# Access Compliance Report

## Public Rights-of-Way

Intersection ID: 2802	Main Street: DOWNFIELD_WOOD_DR	Cross Street: HIGHLAND_CREEK_PY	Location: SW
ADA ID: 591EF5812671	Ramp Type: Perp	Initial Pass/Fail: Fail	Overall Compliance: No
Severity Score: 50			
Codes/Mitigation Info/Possible Solution		Field Measurements/Component Compliance

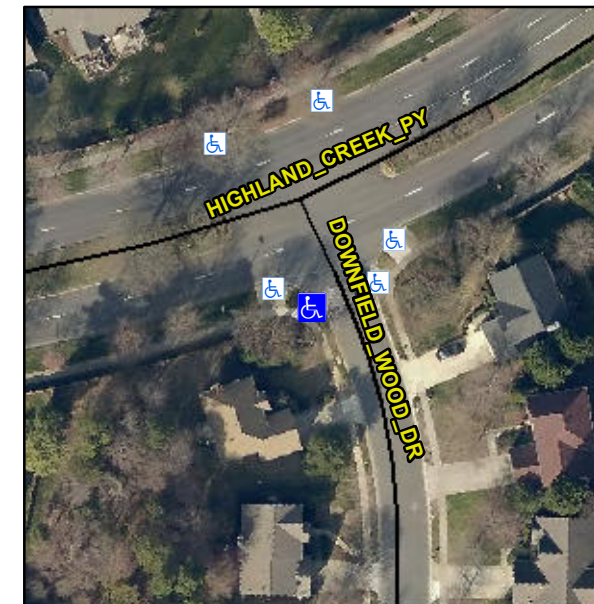
**R304.2.2, R304.5.3**

Compliance	Description	Data	Compliance	Description	Data
N/A	Ramp Length (in)	76.0	No	Ramp Slope (%)	15.4
Yes	Ramp Width (in)	48.0	No	Ramp XSlope (%)	14.0
N/A	Flare Type LT	N/A	N/A	Flare Type RT	N/A
N/A	Flare Slope LT (%)	N/A	N/A	Flare Slope RT (%)	N/A
N/A	Flare Traversable LT?	N/A	N/A	Flare Traversable RT?	N/A
N/A	Landing Length (in)	N/A	N/A	DWS Provided?	N/A
N/A	Landing Width (in)	N/A	N/A	DWS Contrast?	N/A
N/A	Landing Slope (%)	N/A	N/A	DWS Length (in)	N/A
N/A	Landing X Slope (%)	N/A	N/A	DWS Full Width?	N/A
N/A	Landing Curb? (Y/N)	N/A	N/A	DWS Offset (in)	N/A
N/A	Shared Landing?	N/A			
N/A	Gutter Ponding?	N/A	N/A	Gutter Slope (%)	N/A
N/A	Gutter Lip Ht (in)	N/A	N/A	Gutter X Slope (%)	N/A
N/A	Painted X Walk1?	Yes	N/A	Painted X Walk2?	N/A
	X Walk 1 Direction	To E		X Walk 2 Direction	N/A
N/A	X Walk 1 Width (in)	93.0	N/A	X Walk 2 Width (in)	N/A
	X Walk 1 Slope (%)	1.3		X Walk 2 Slope (%)	N/A
	X Walk 1 X Slope (%)	13.8		X Walk 2 X Slope (%)	N/A

**Remove & Replace Entire Ramp.**
